ADDENDUM NO. 03

Franklin Central High School Addition and Renovations Phase 3A.1
6215 S. Franklin Rd
Indianapolis, IN 46259

ADDENDUM NO. 3 (THREE)

DATE: April 4, 2025
PROJECT: Additions & Renovations to Franklin Central High School
Phase 3A.1
OWNER: Franklin Township Community School Corporation
PROJECT NO.: 2024040.00

Drawing Title:
**MECHANICAL PIPING PLAN -
UNIT H**

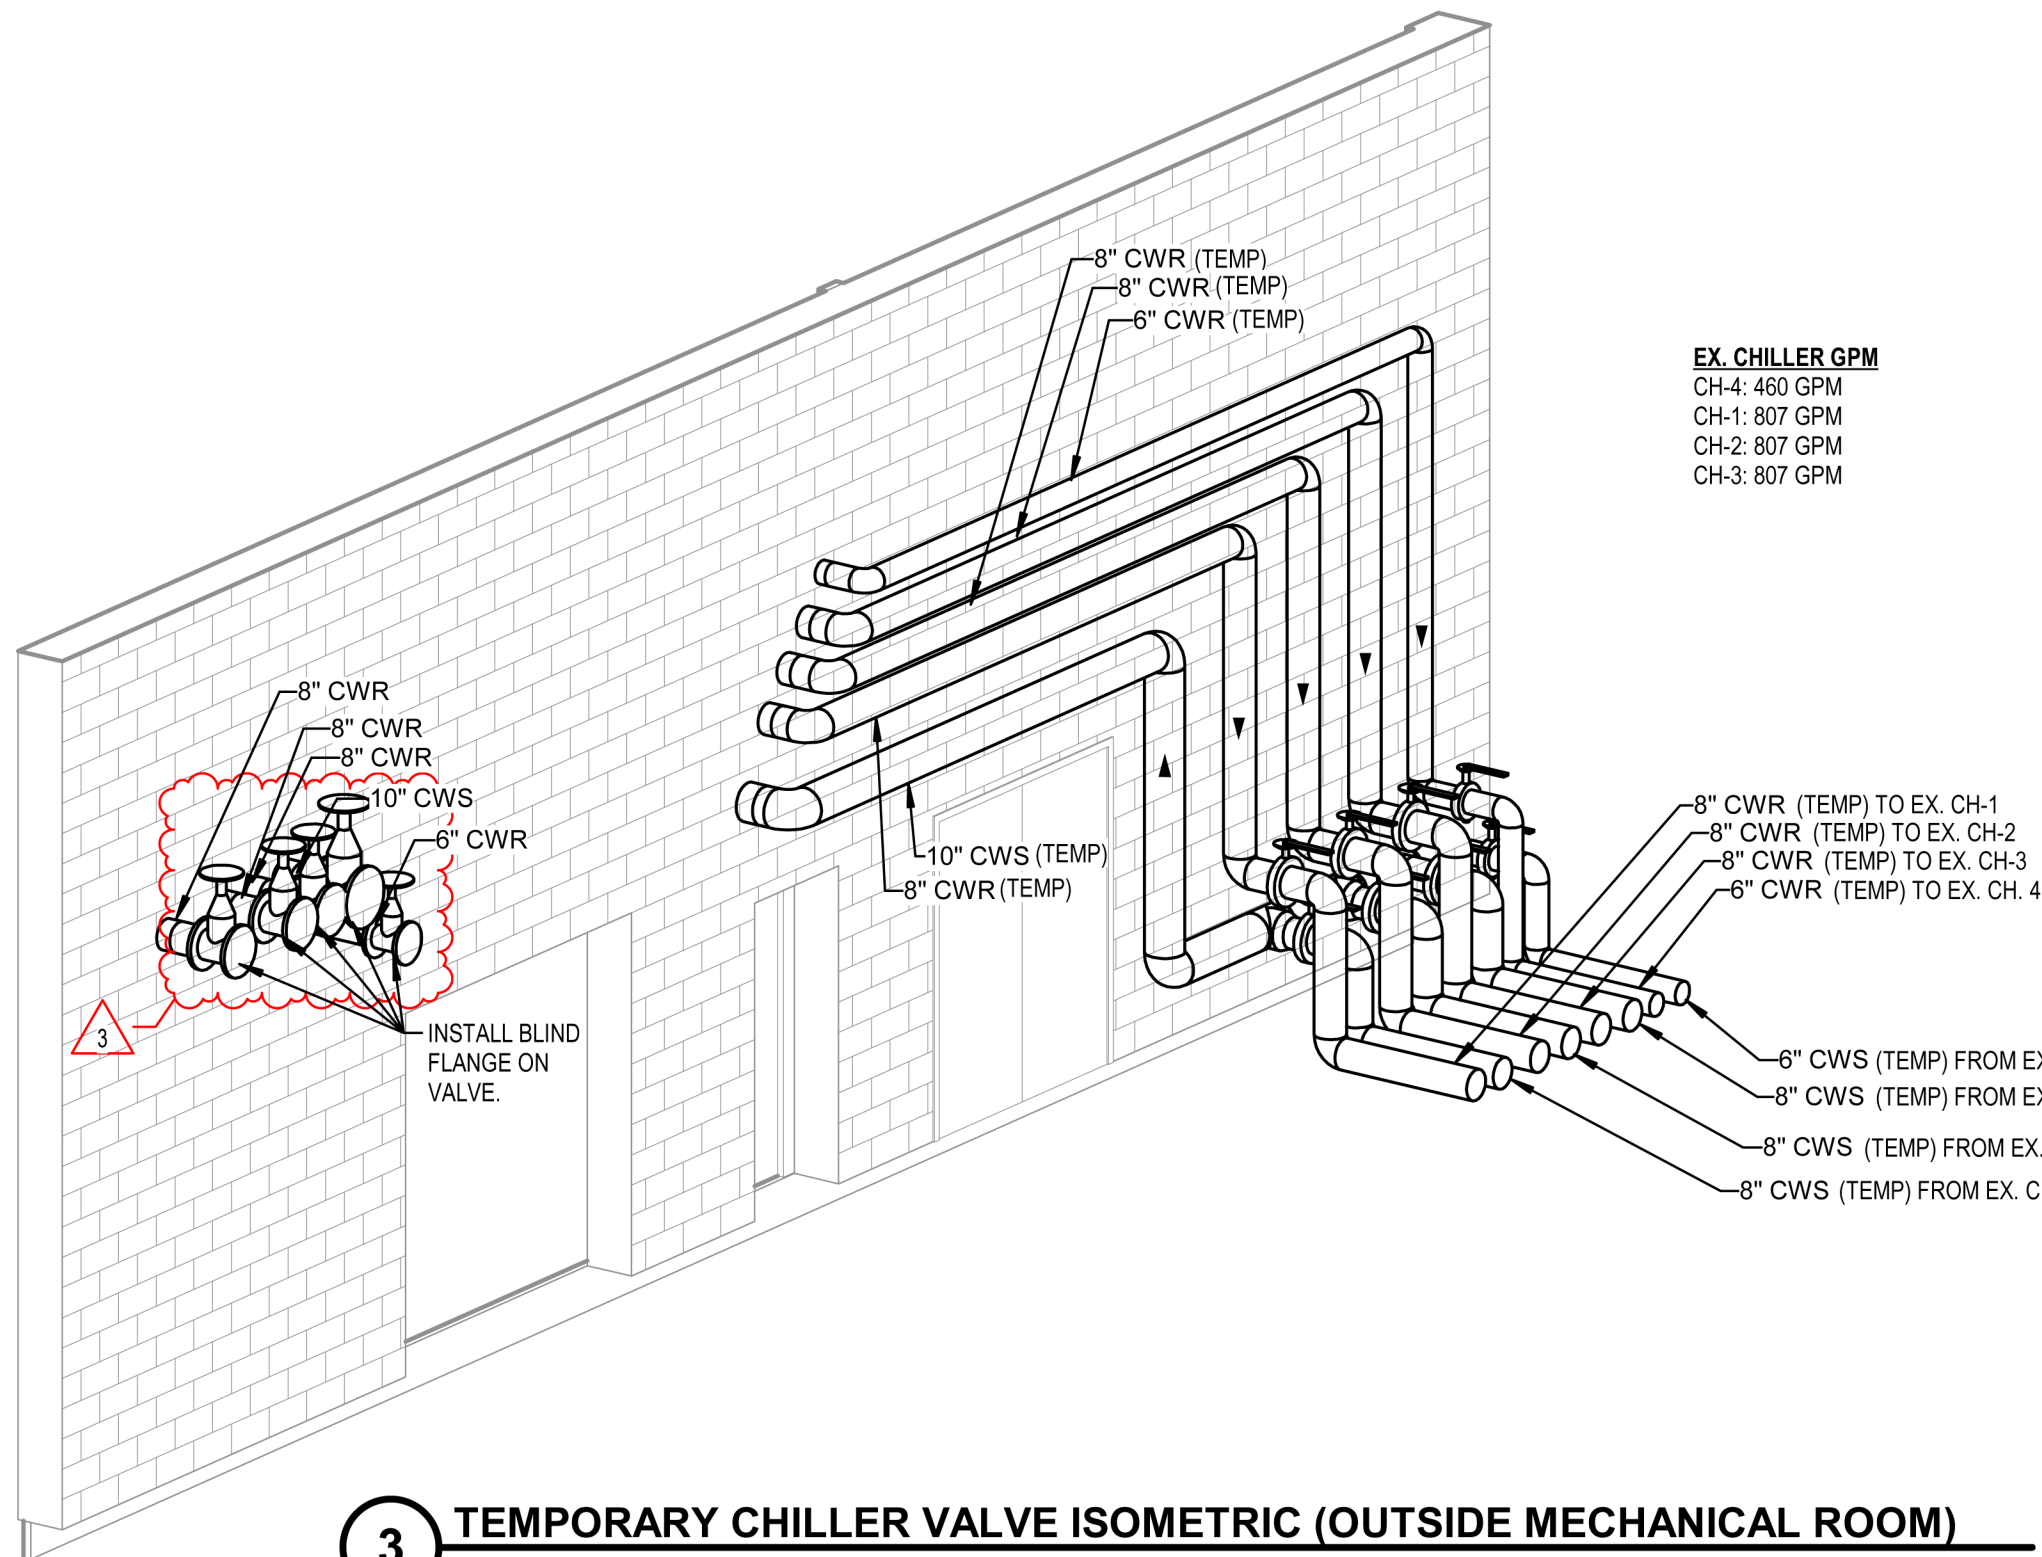
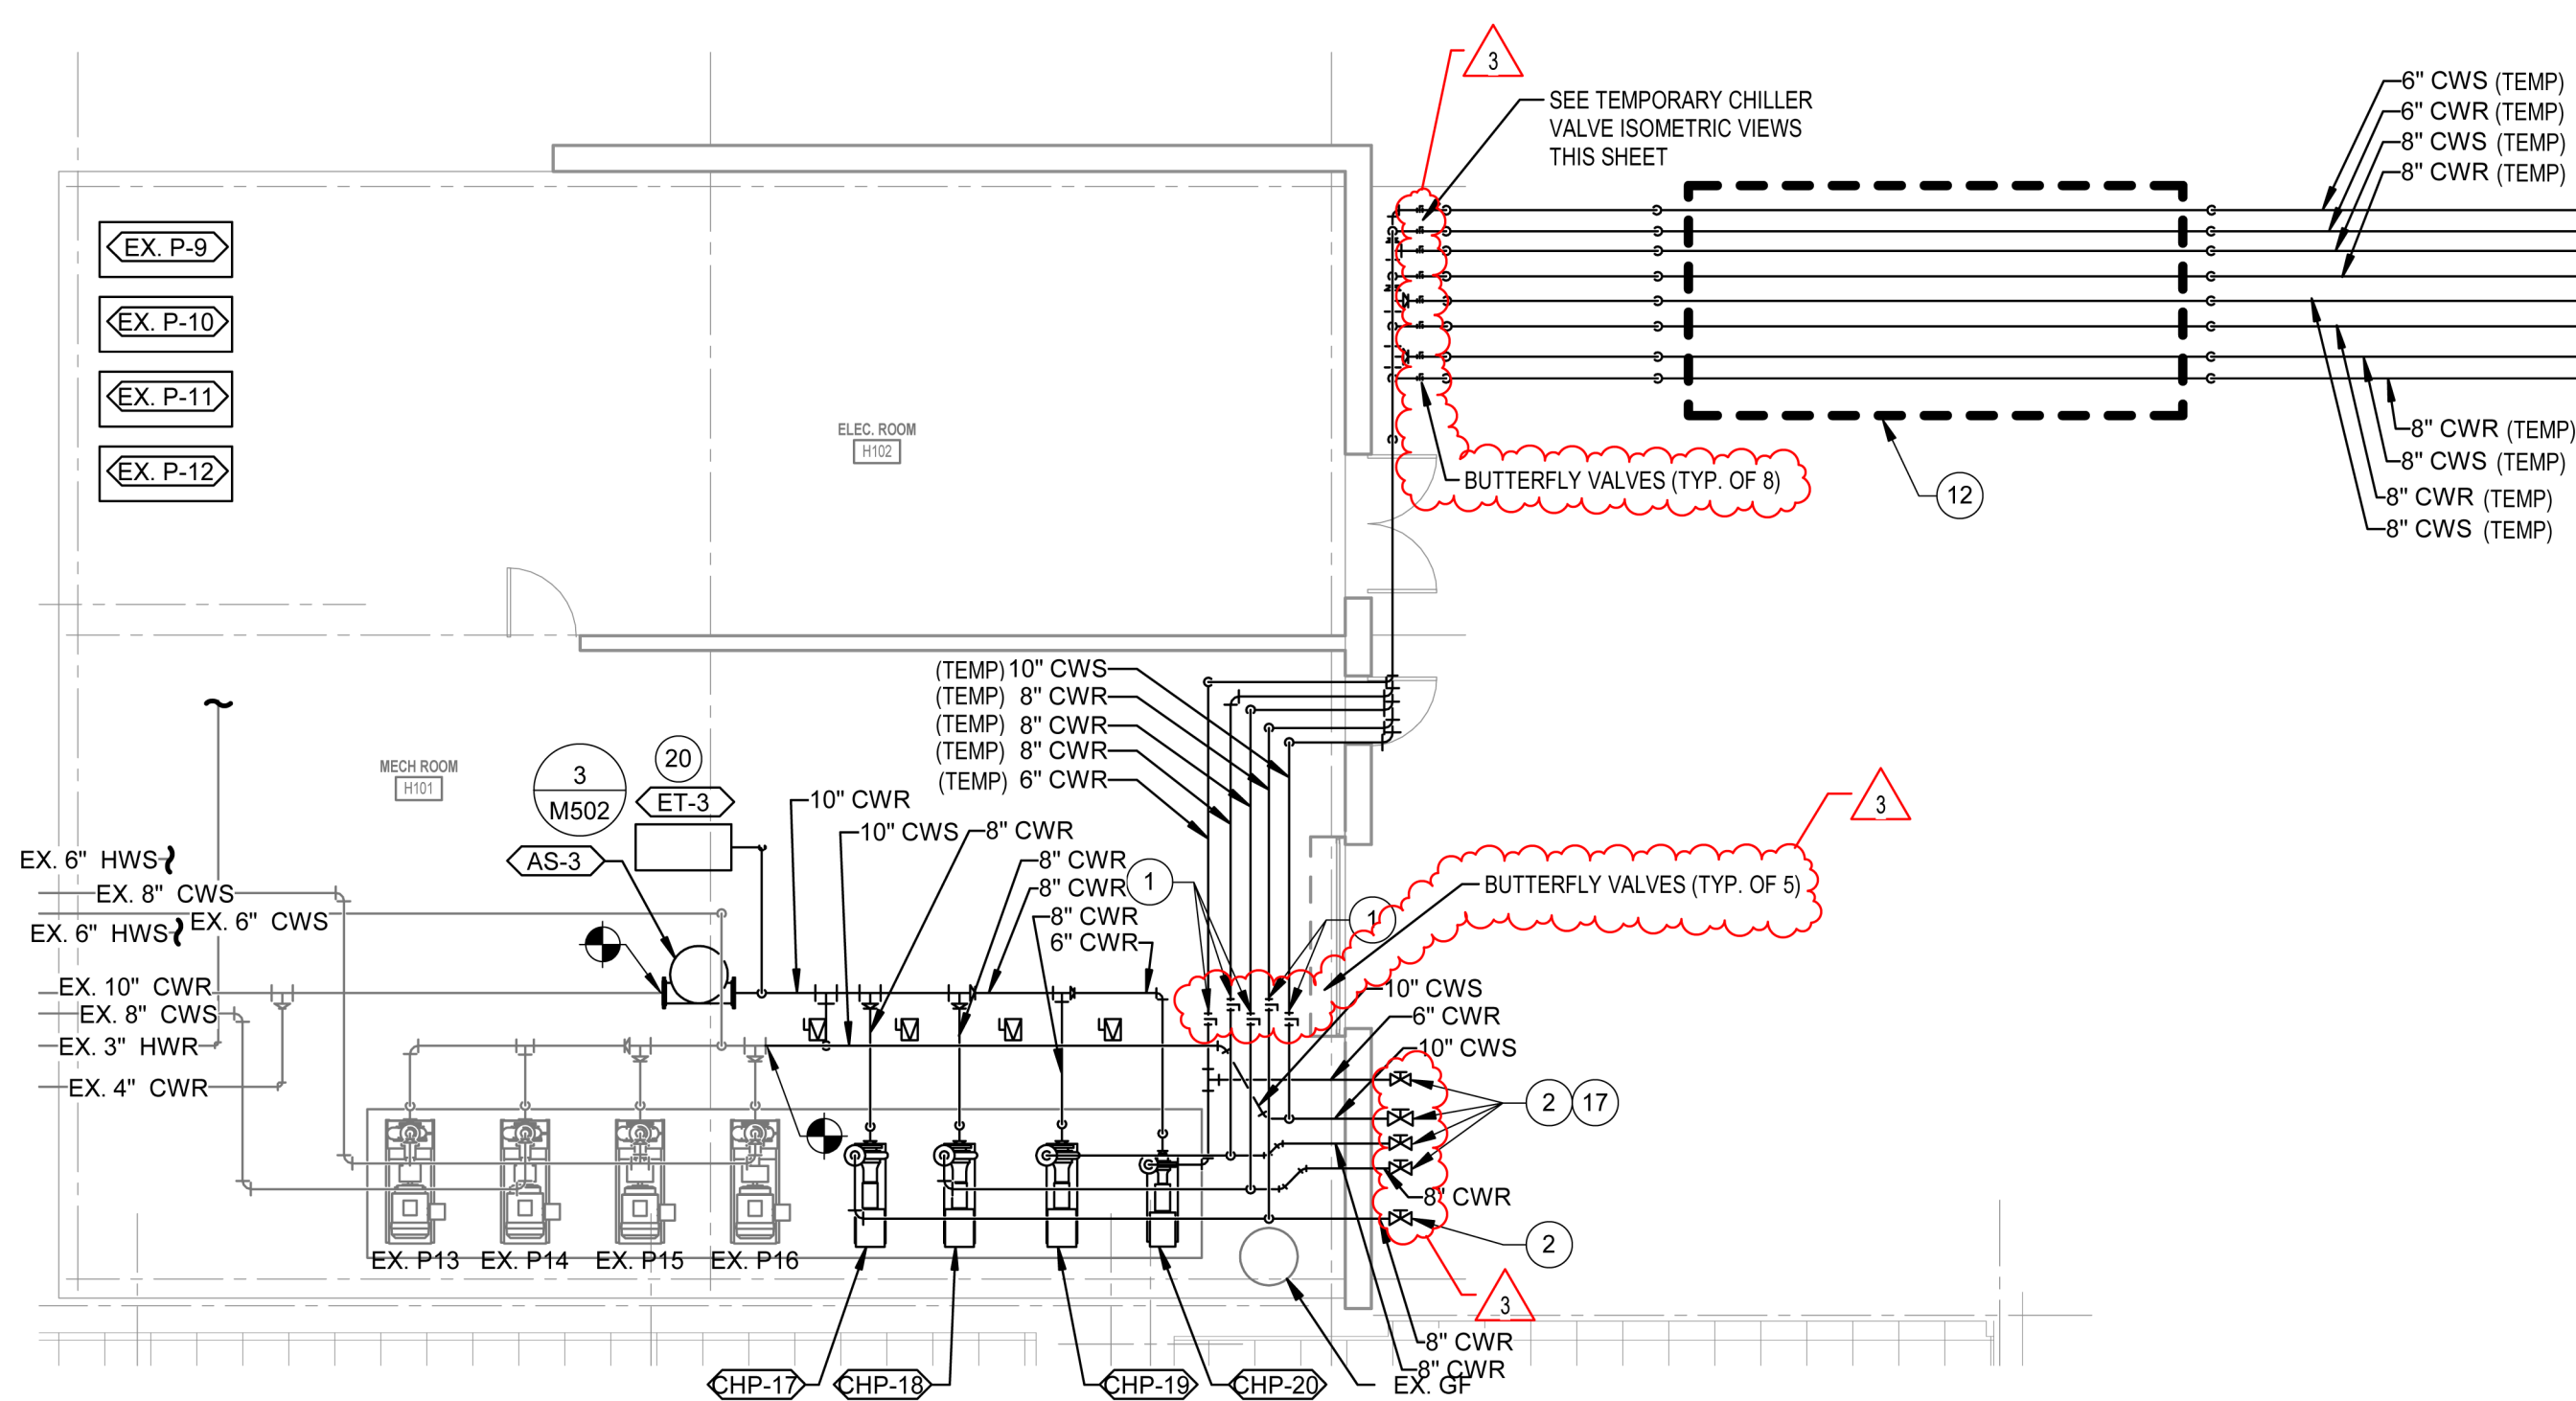
- 3-3 MP1H: Replace drawing in its entirety with attached revision indicating updated valves to gate and denoting locations of butterfly valves.
